JOB NO. MA24-04

LAHAINA SMALL BOAT HARBOR WATER SYSTEM LEAK ASSESSMENT AND REPAIR LAHAINA, MAUI, HAWAII

NOTE: THESE AS-BUILT PLANS HAVE BEEN MARKED UP TO SHOW THE SCOPE OF WORK FOR WATER SYTEM LEAK ASSESSMENT, PRESSURE TESTING, REPAIR AND NEW WATER SYSTEM WORK.

### PROFILE - WHARF STREET EXTENSION

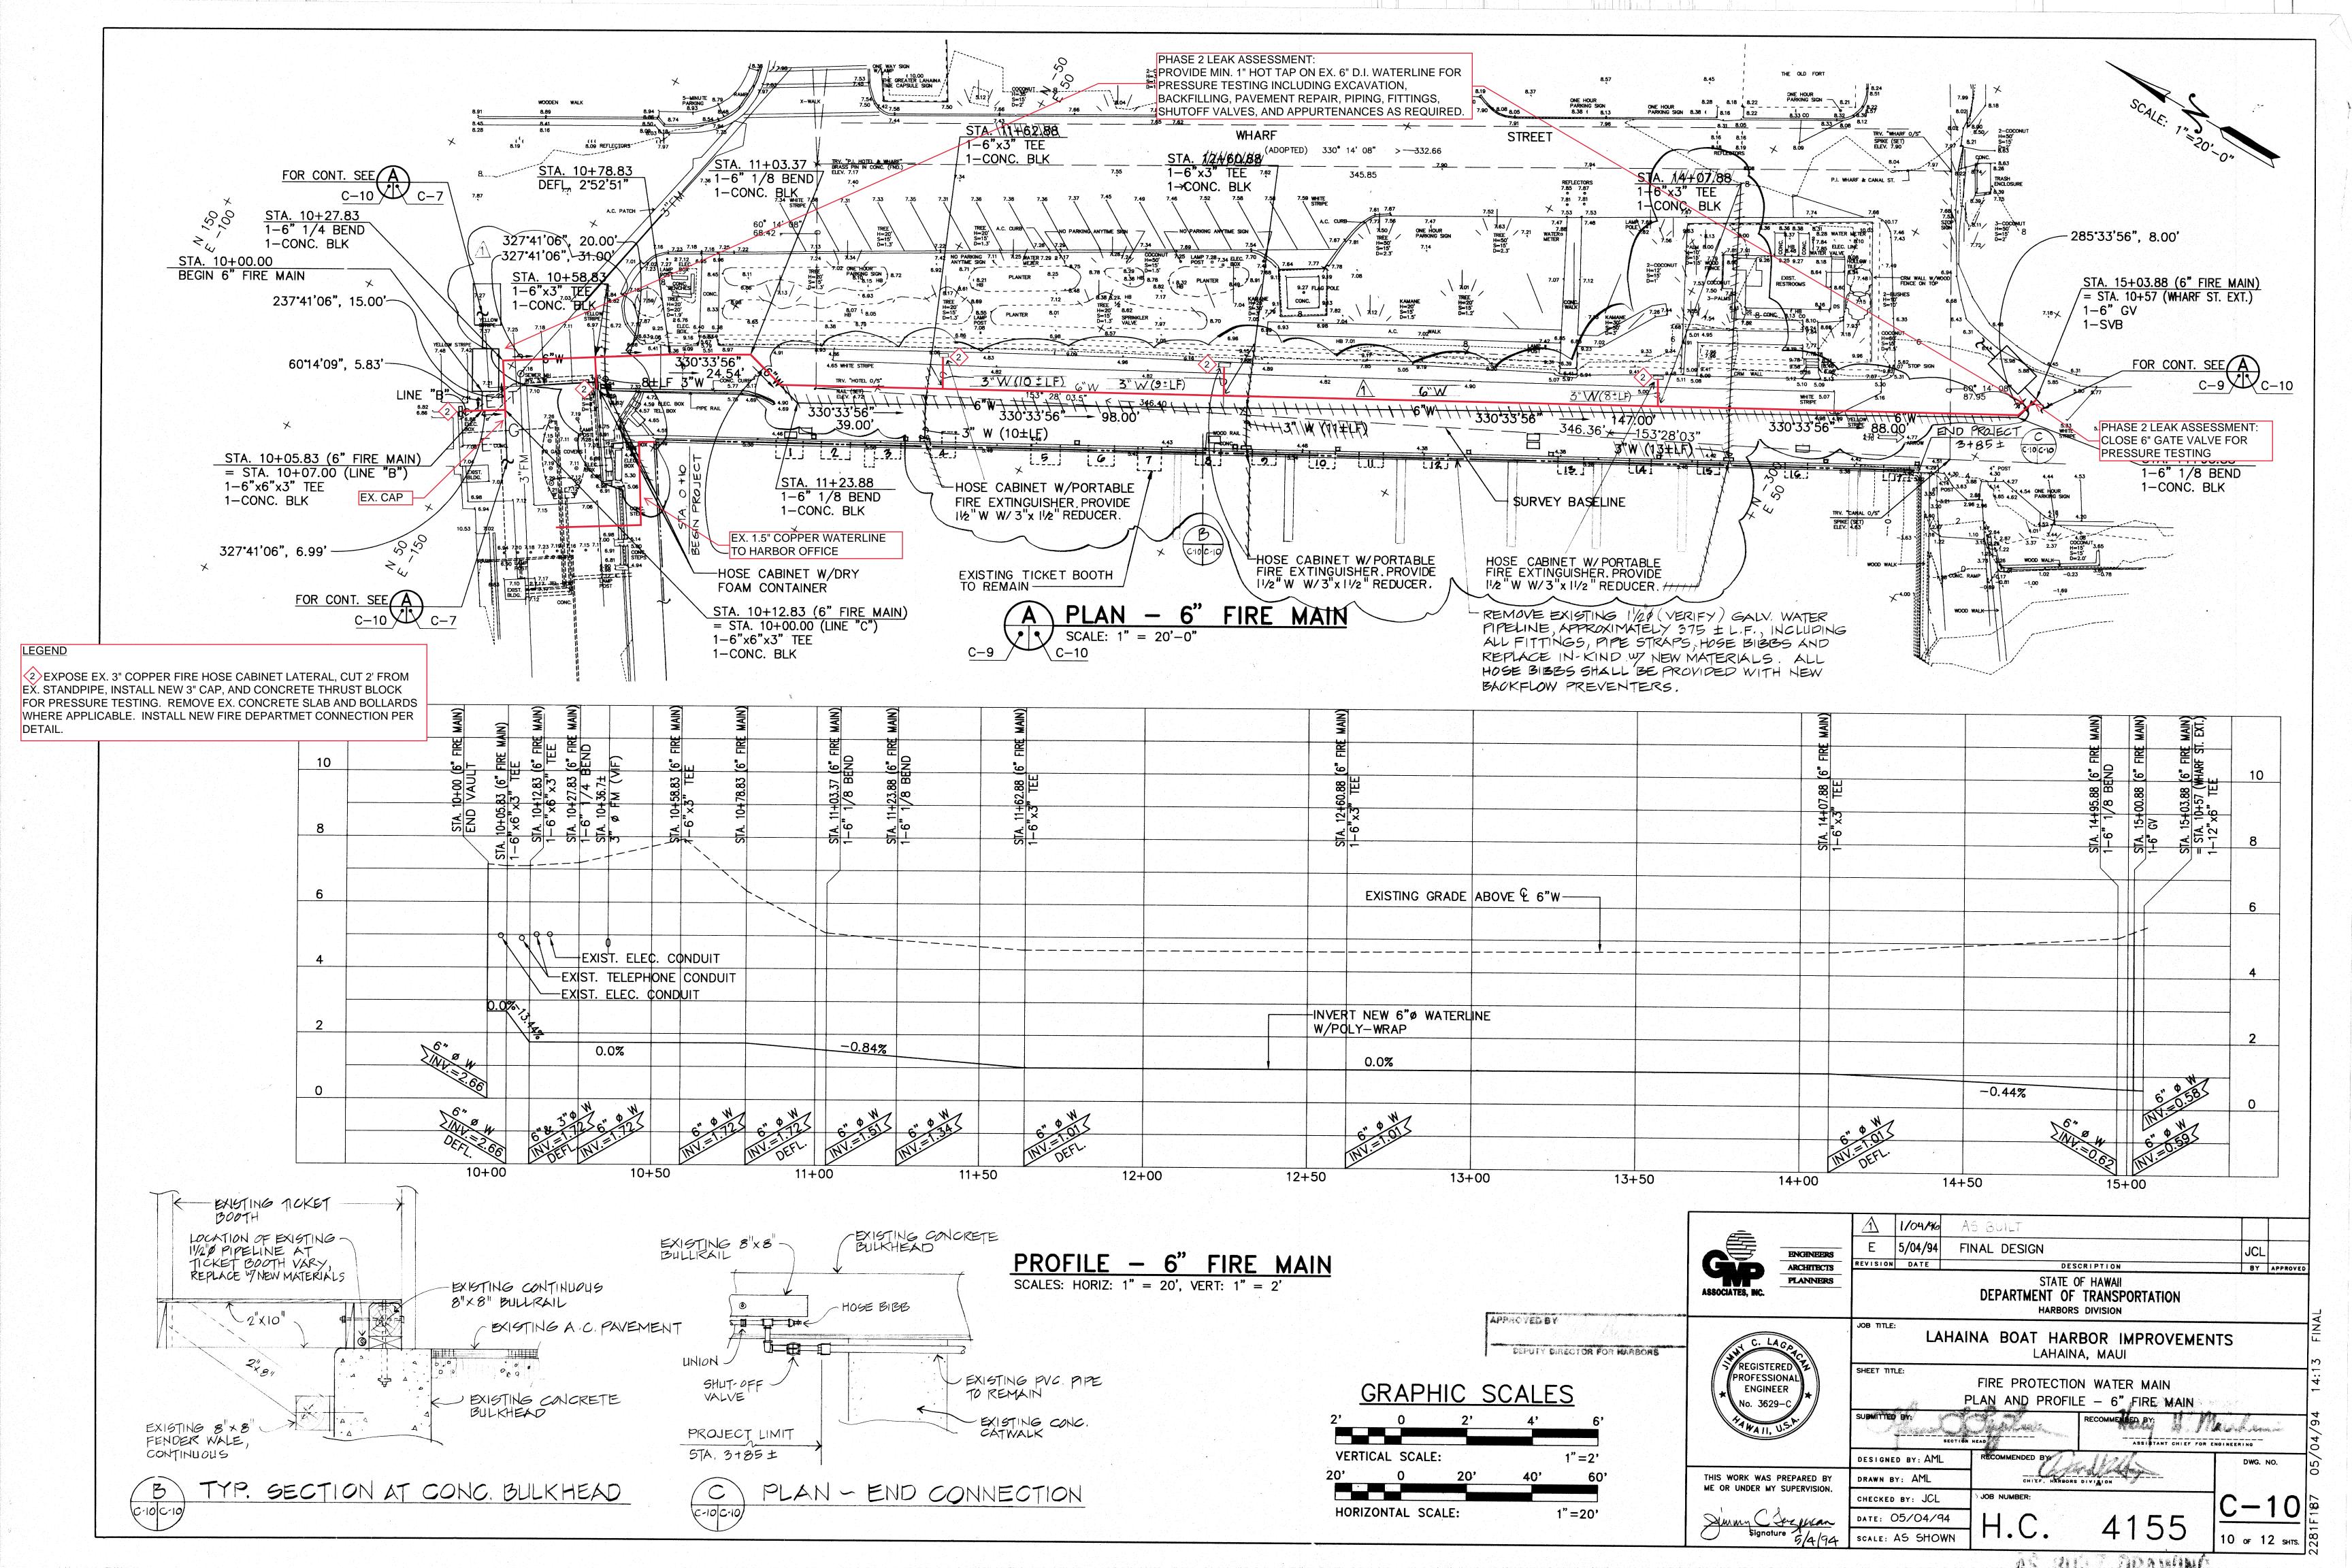
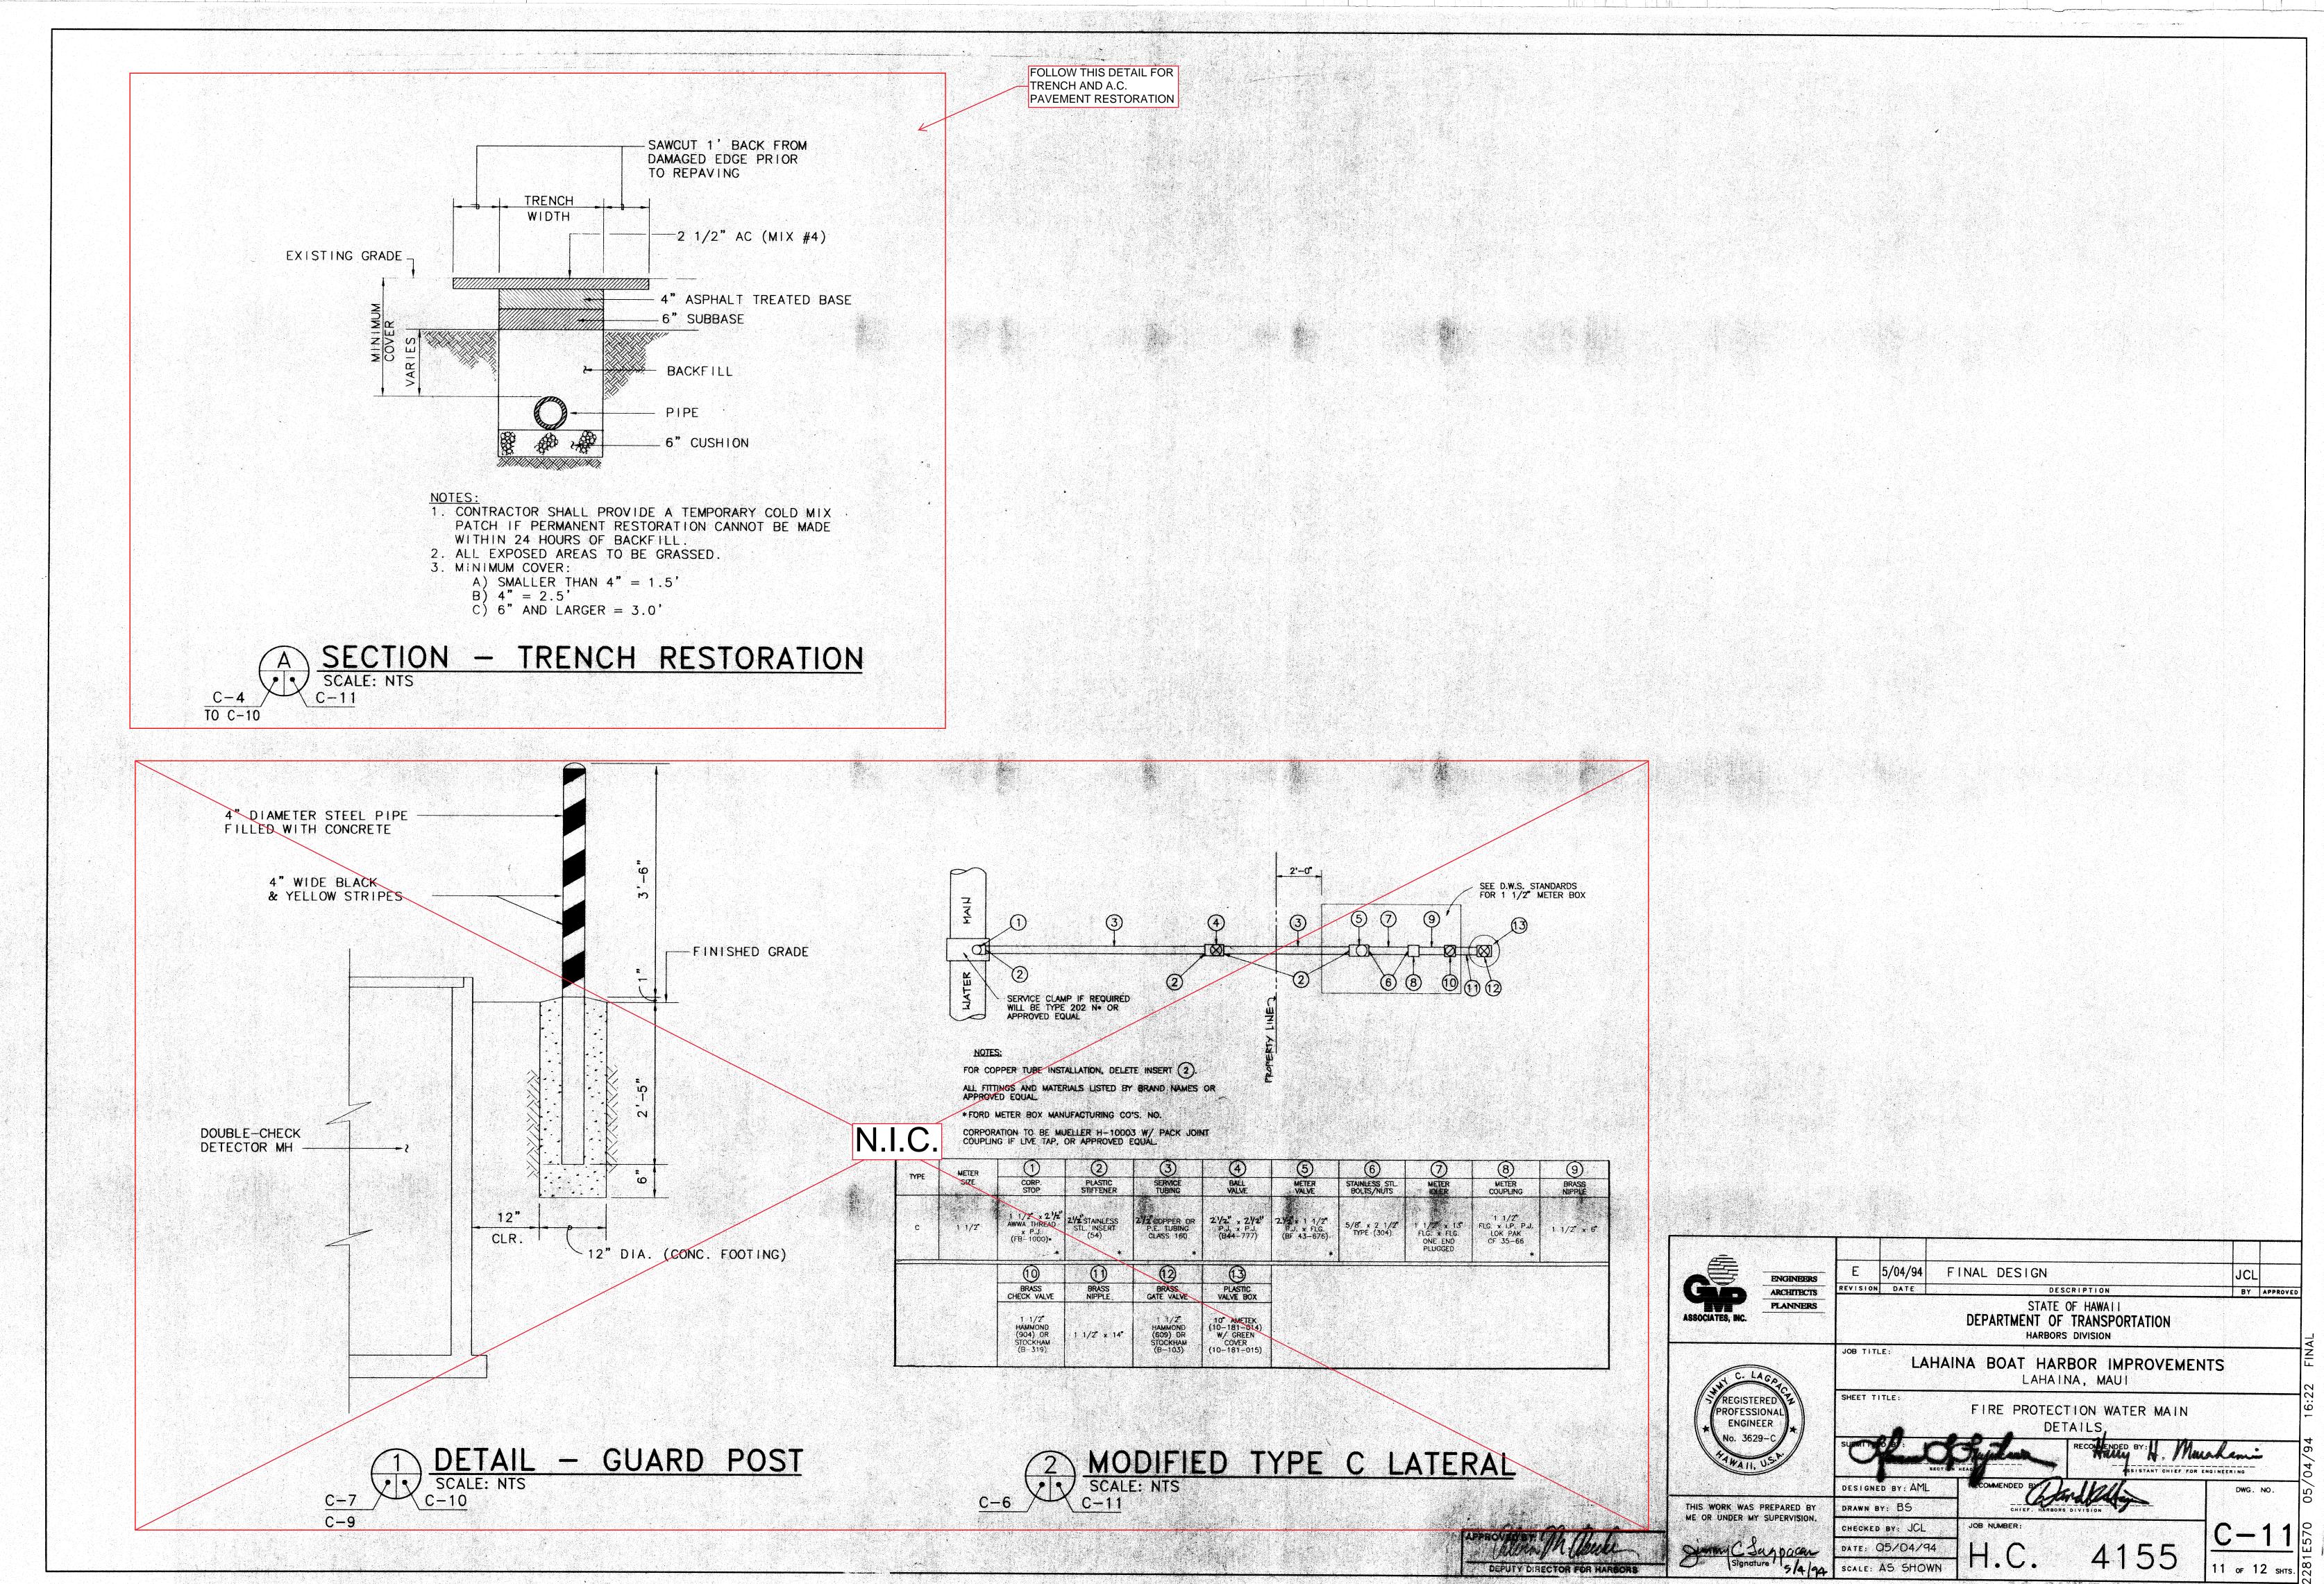
(1) EXPOSE EX. 6" D.I. FH LATERAL, CUT 4' FROM EX. FH, INSTALL NEW 6" CAP AŇD CONCRETE THRUST BLOCK FOR PRESSURE TESTING. INSTALL NEW FH PER DETAIL.

2 EXPOSE EX. 3" COPPER FIRE HOSE CABINET LATERAL, CUT 2' FROM EX. STANDPIPE, INSTALL NEW 3" CAP, AND CONCRETE THRUST BLOCK FOR PRESSURE TESTING. REMOVE EX. CONCRETE SLAB AND BOLLARDS WHERE APPLICABLE. INSTALL NEW FIRE DEPARTMET CONNECTION PER DETAIL.

(3) INSTALL NEW CLEANOUT PER DWS STD. DTL. V21 AT END OF EX. 12" D.I. WATERLINE.

4 INSTALL NEW CLEANOUT ON NEW 2" COPPER WATERLINE "B": 1 EA. 2" COPPER 1/4 BEND, 2" COPPER VERT. RISER PIPE (LENGTH AS REQ'D), AND 2" BRONZE BALL VALVE IN TYPE "X" METER BOX.

WATERLINE "B": INSTALL NEW 2" COPPER WATERLINE (700 LF) WITH 1/8 BENDS, 6' OFFSET FROM FACE OF CONC. BULKHEAD AS SHOWN. PROVIDE MIN. 1" TEMP. CONNECTION ON SOUTH END AND 2" CAP ON NORTH END FOR PRESSURE TESTING, INCLUDING ALL NEC. PIPING, FITTINGS, SHUTOFF VALVES, AND APPURTENANCES. RESTORE A.C. PAVEMENT AS NEC. SEE SHEET C-8 FOR CONT
